REQUEST FOR INFORMATION	DATE: October 28, 2016	NO.: RFI-338
--------------------------------	-------------------------------	---------------------

Project Name:	15051-Webster University Interdisciplinary Science Building	Project No.: 15051
---------------	---	--------------------

Subject: Projected window head details

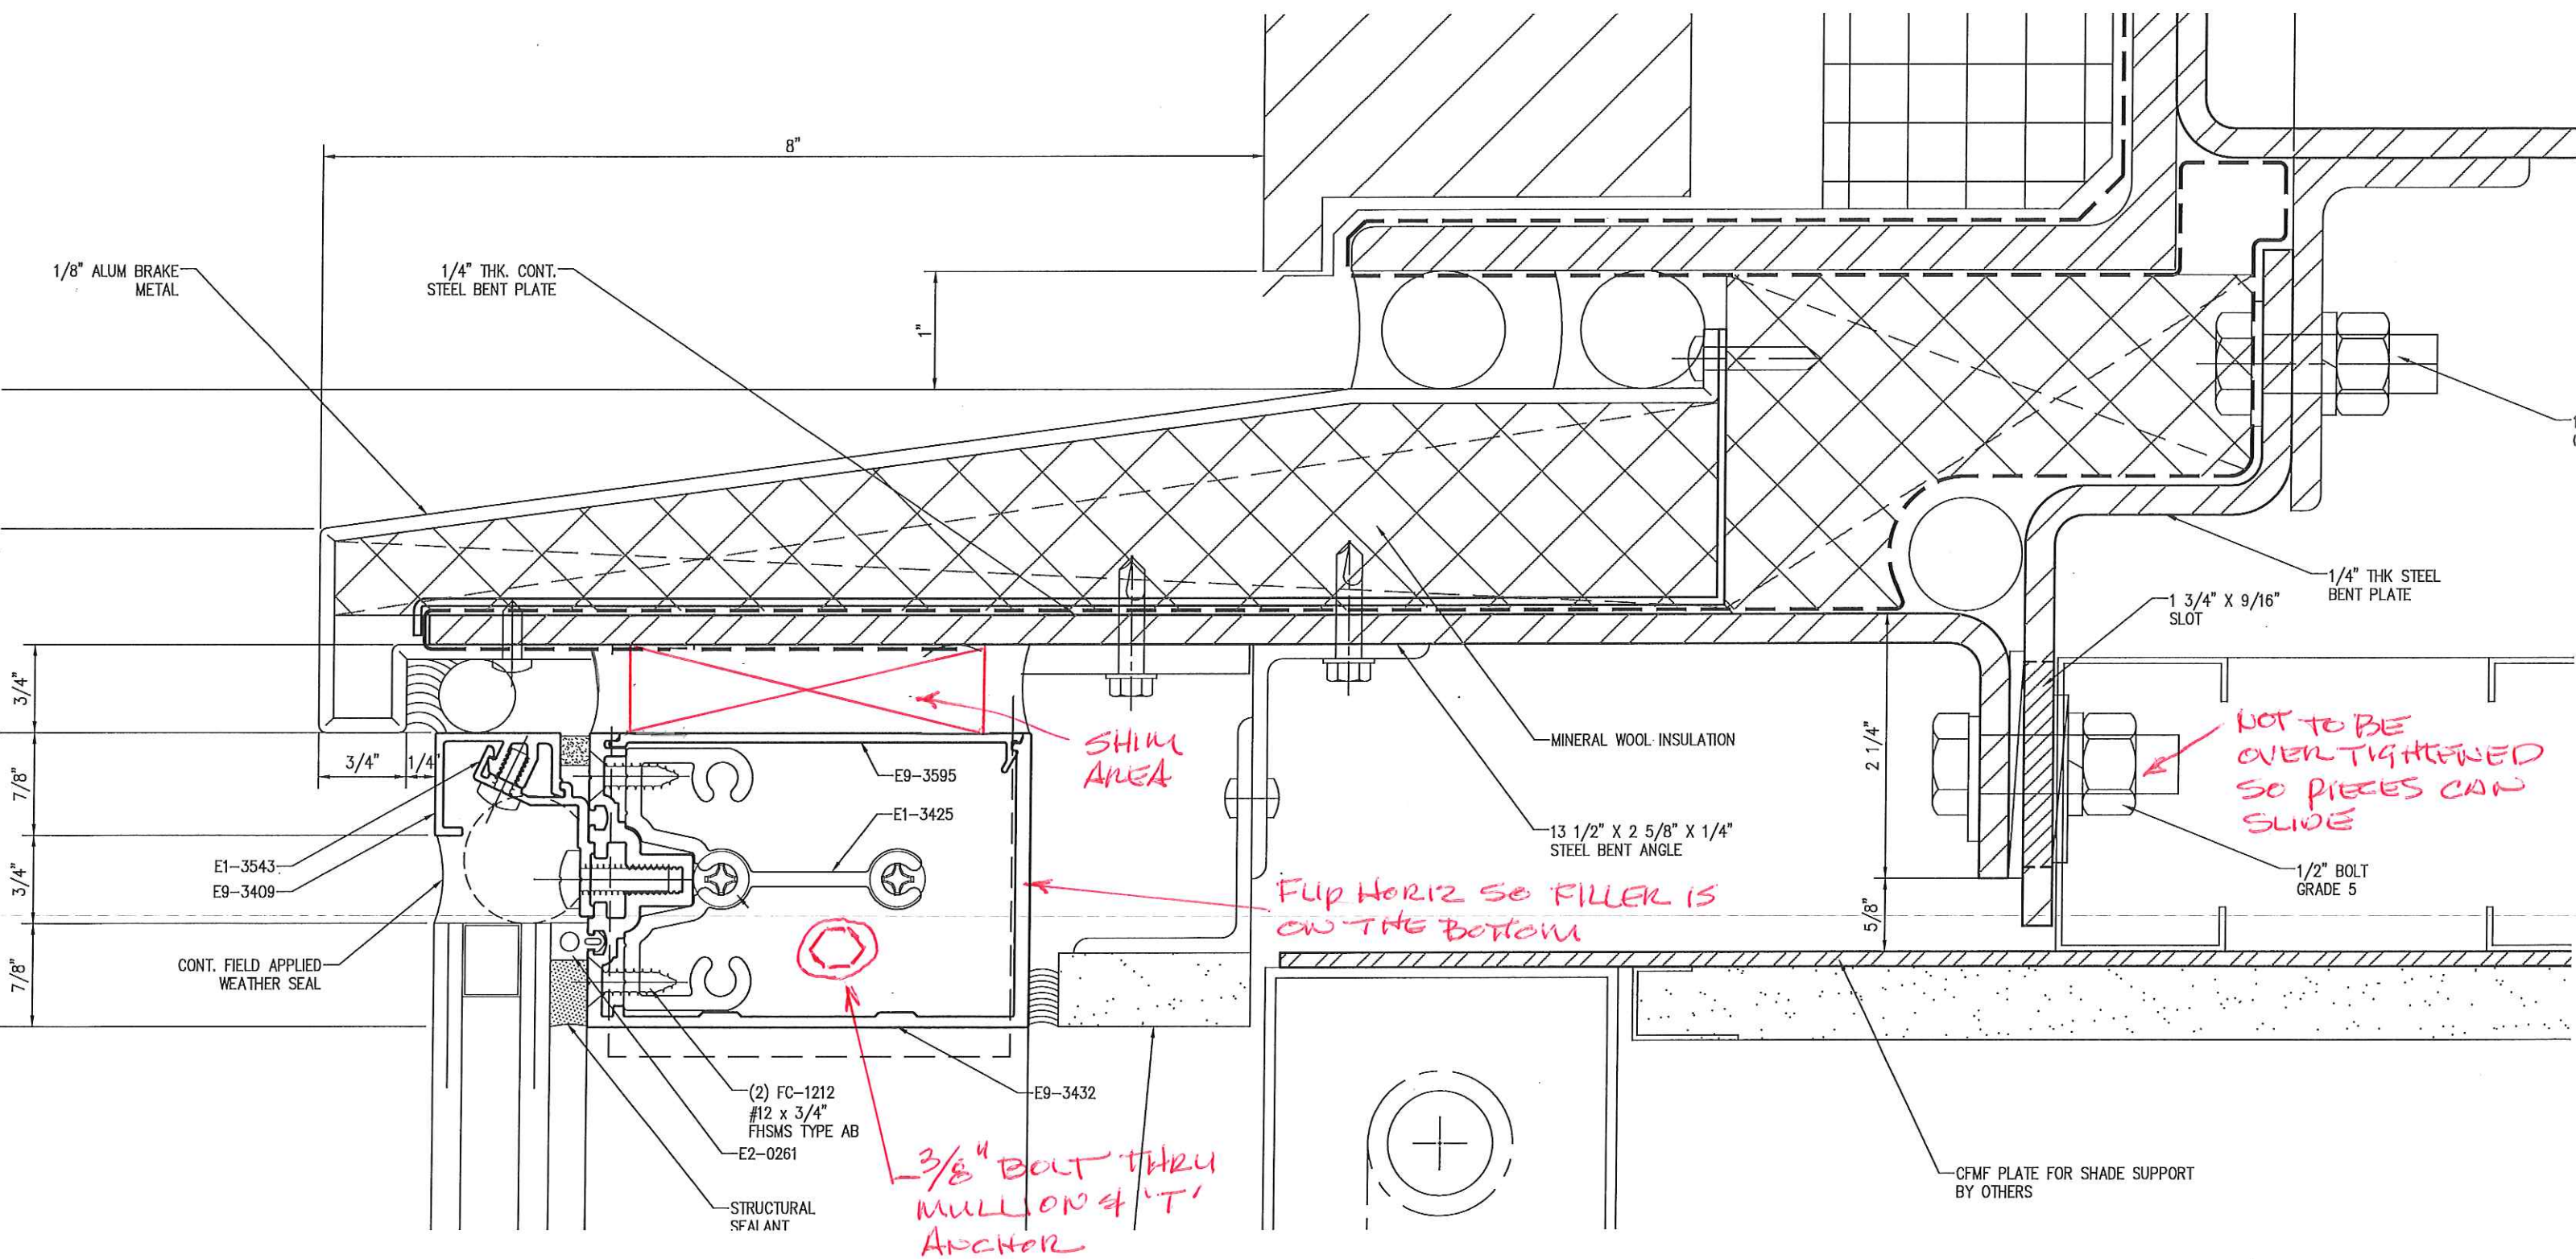
1. In order for the horizontal plate to be able to slide up and down as planned, can the plate be fastened to the window head per the attached detail (see attached markup). Without this fastening to the window head, the plate may not slide up and down and only flex up and down from the fixed bolt connection because it cannot overcome the friction.
2. Please advise if the thermal analysis can be revised on the North projected window per JEI memo (see attached) in order to minimize the movement joint size.

Comments will be provided on the detail submitted in the revised curtain wall shop drawing submittal submitted on 11/08/16.
